**ACKNOWLEDGEMENT OF RECEIPT OF REPRESENTATION  
DEVELOPMENT APPLICATION NO: 201835106  
BLOCK: 17 SECTION: 47 DIVISION: TURNER**

**Representation on Development Application 201835106  
Multi Dwelling -Demolition – 12 Unit Development – Lease Variation  
Blocks 17, 18, 19 section 47 Turner 22, 24, 26 Greenway Street**

Please accept this letter as part of the response to the request for Further Information issued on 31<sup>st</sup> September 2019.

REGULATED TREE PLAN  
Scale 1:100 @ A1

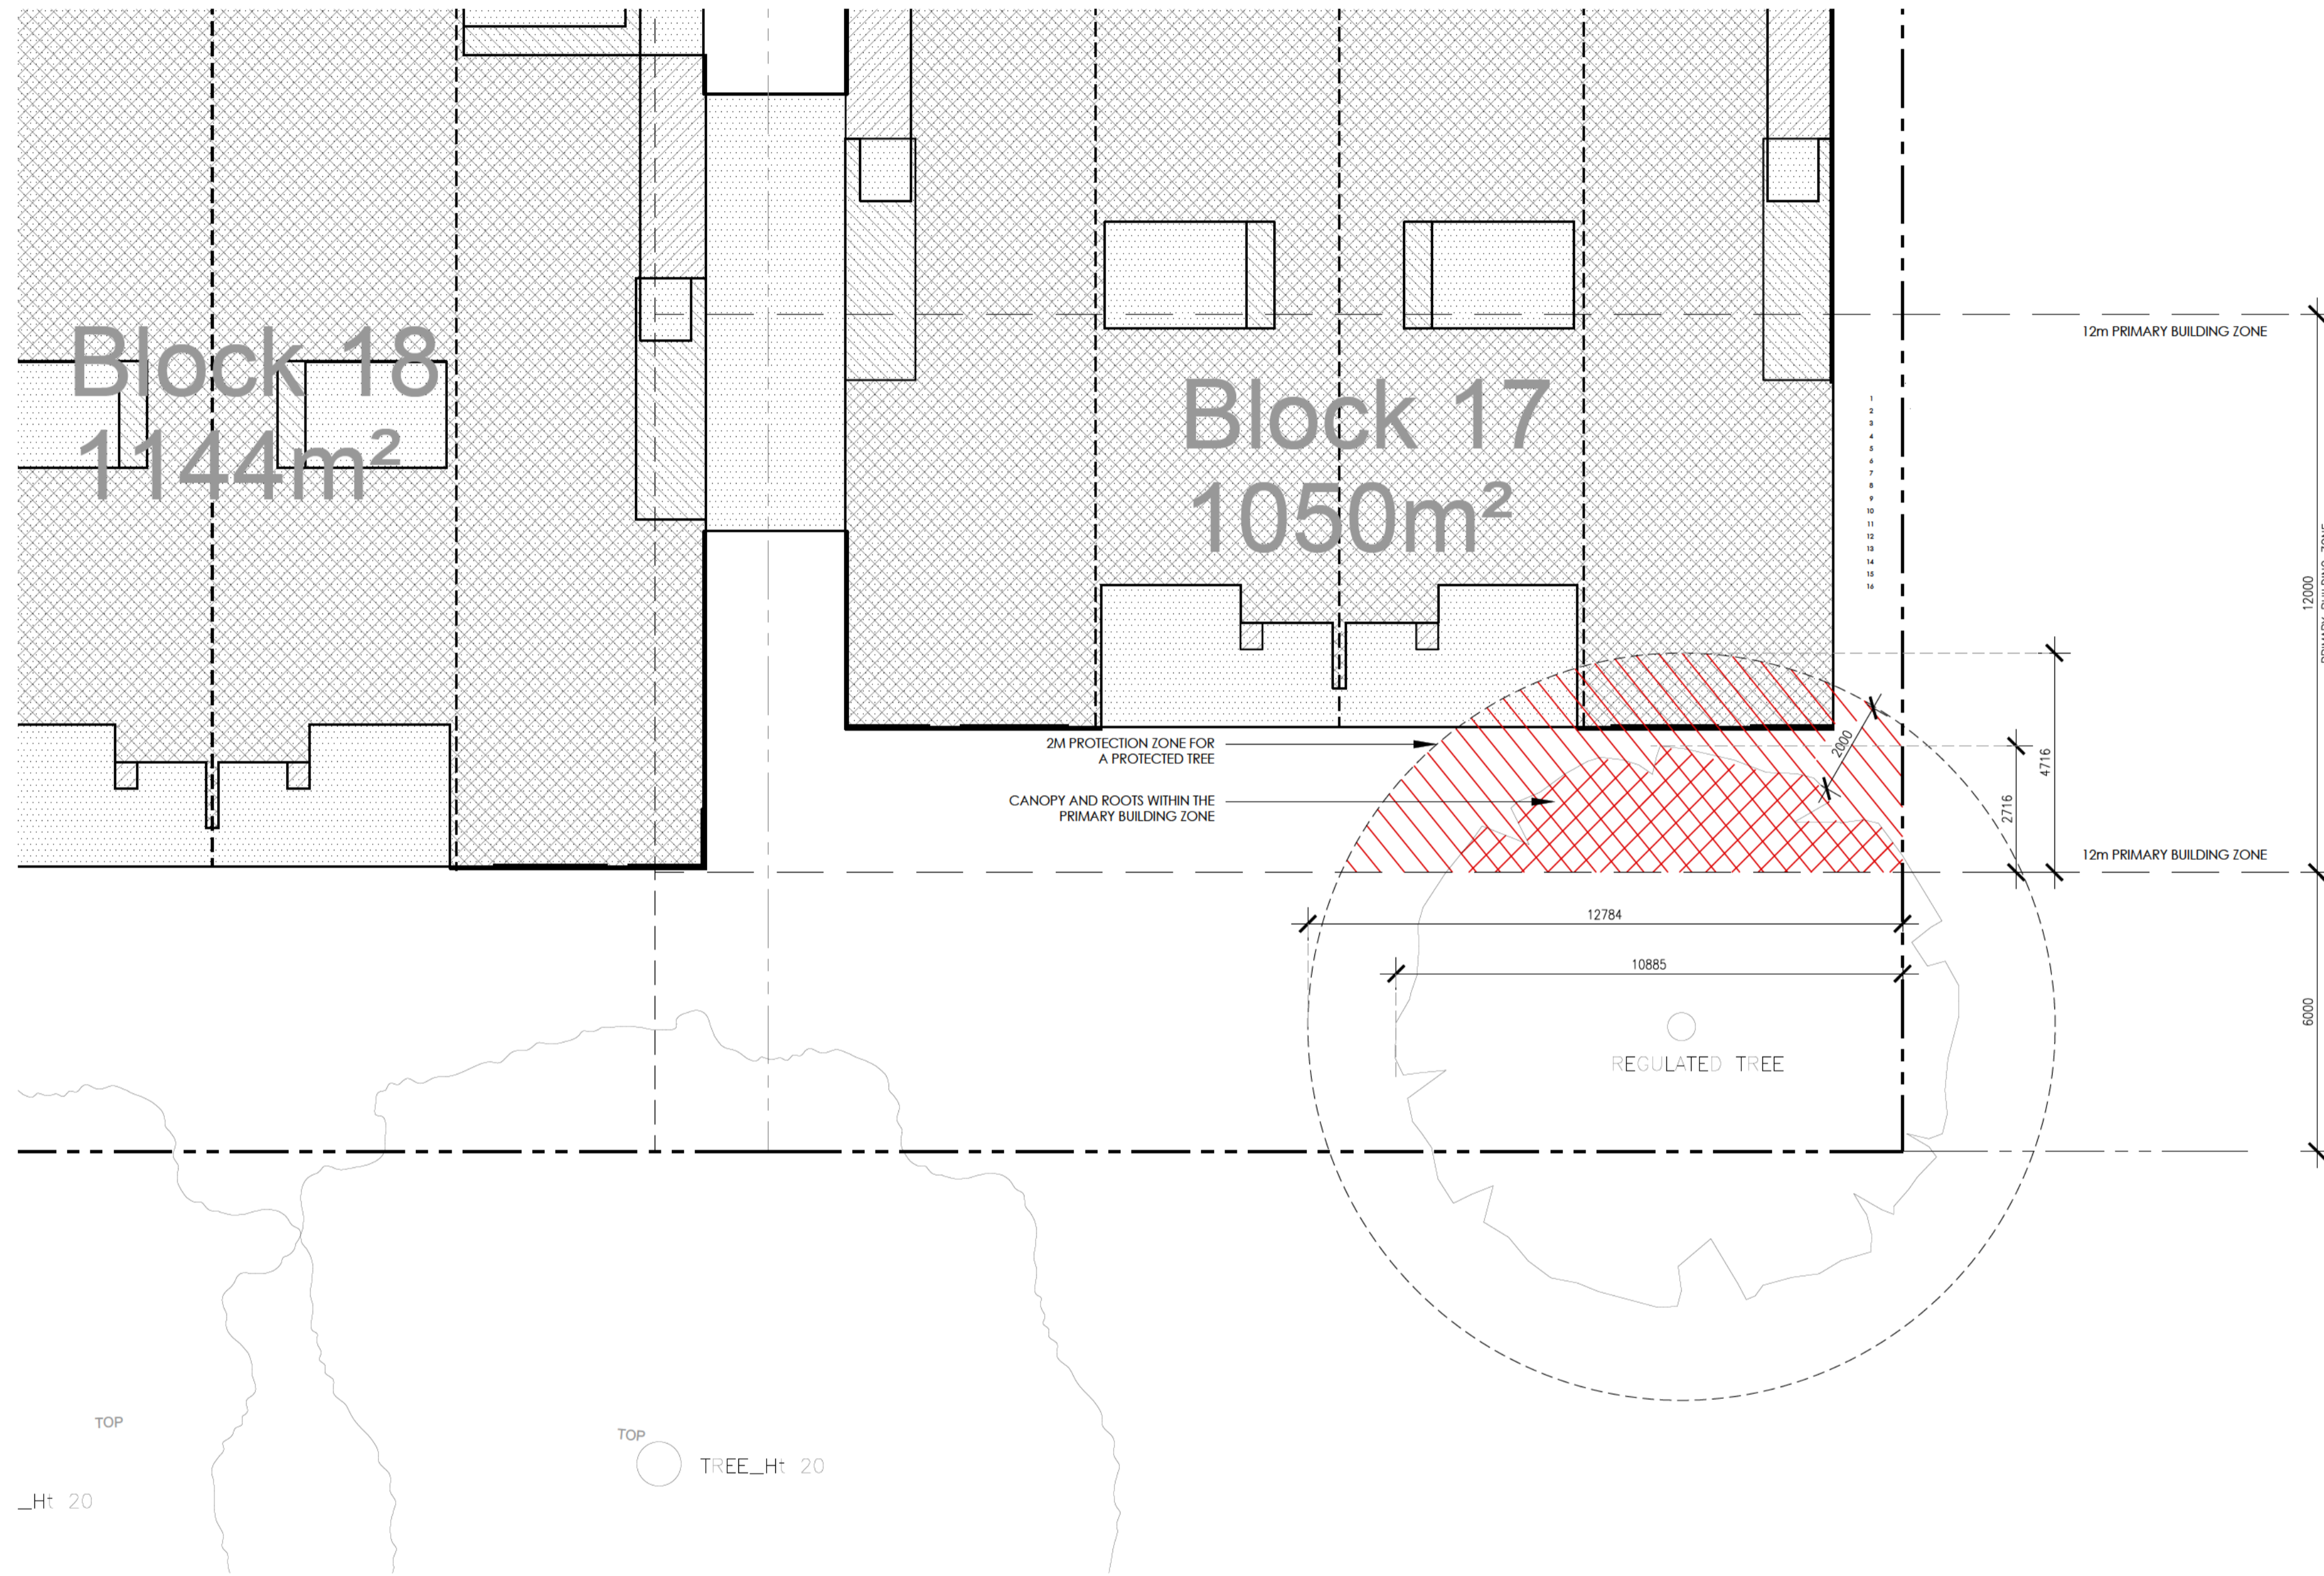
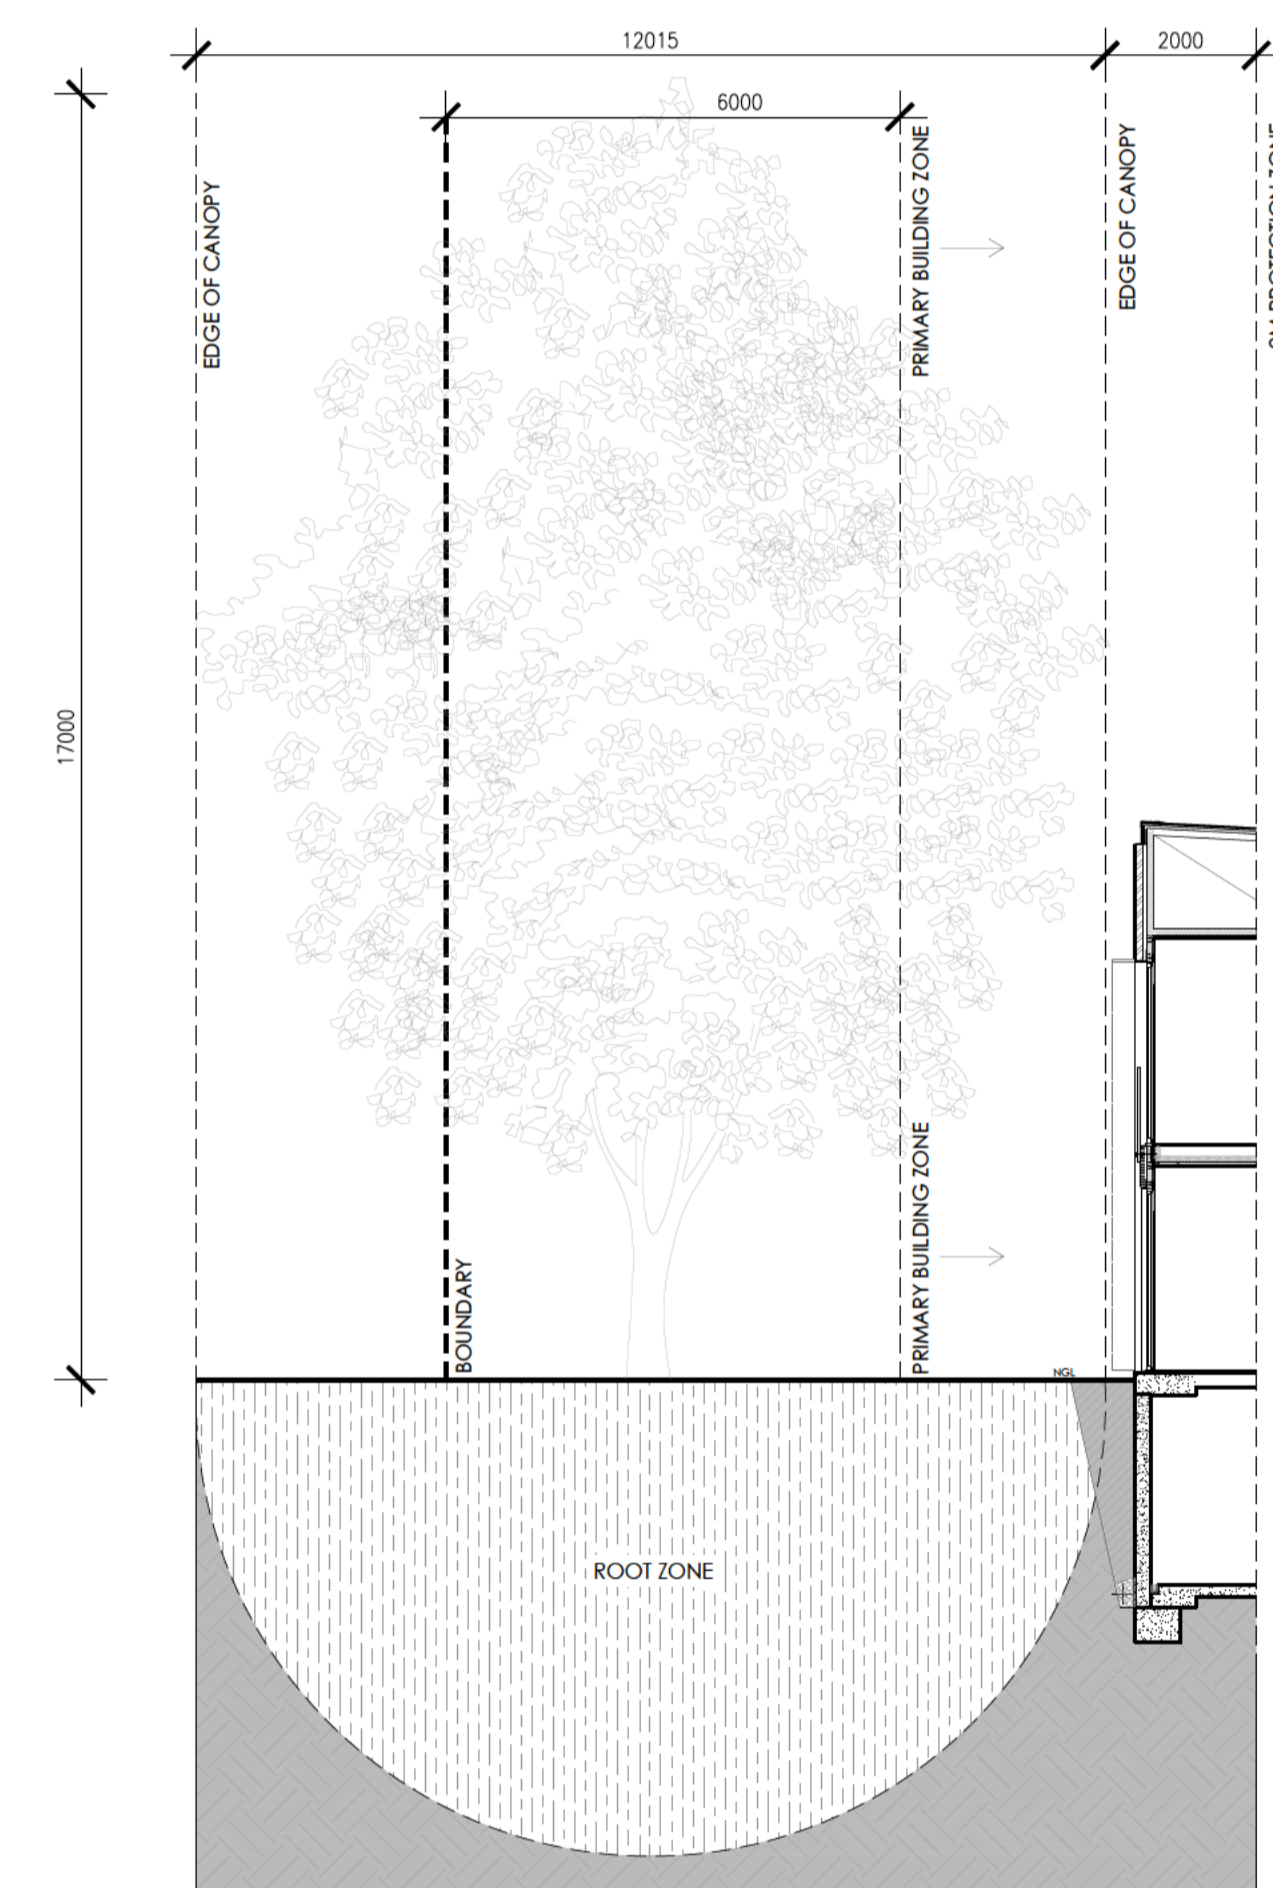
The development application is not supported as Tree 1 ***Cupressus sempevirens***, Tree 5 ***Casuarina cunninghamiana*** and Tree 8 ***Liquidamber styraciflua*** proposed for removal are regulated trees of **Medium Quality** that do not meet criteria for removal under the Tree Protection ACT 2005. There is also a regulated (Prunus) Cherry Tree (not noted on any of the plans) located on the western neighbouring lease 28 Greenway Street (Block 20 Section 47) that has a basement cut approximately 3m from the trunk of the tree. Whilst it is felt that the tree will endure the basement cut the tree will have to have severe/disfiguring pruning undertaken to gain suitable 2 storey unit clearance. A Tree Management Plan clarifying how this tree will have successful tree root protection (possible hydrovac) to see if there are major roots in the cut area and what is proposed in regards to how the overhanging foliage is to be managed.
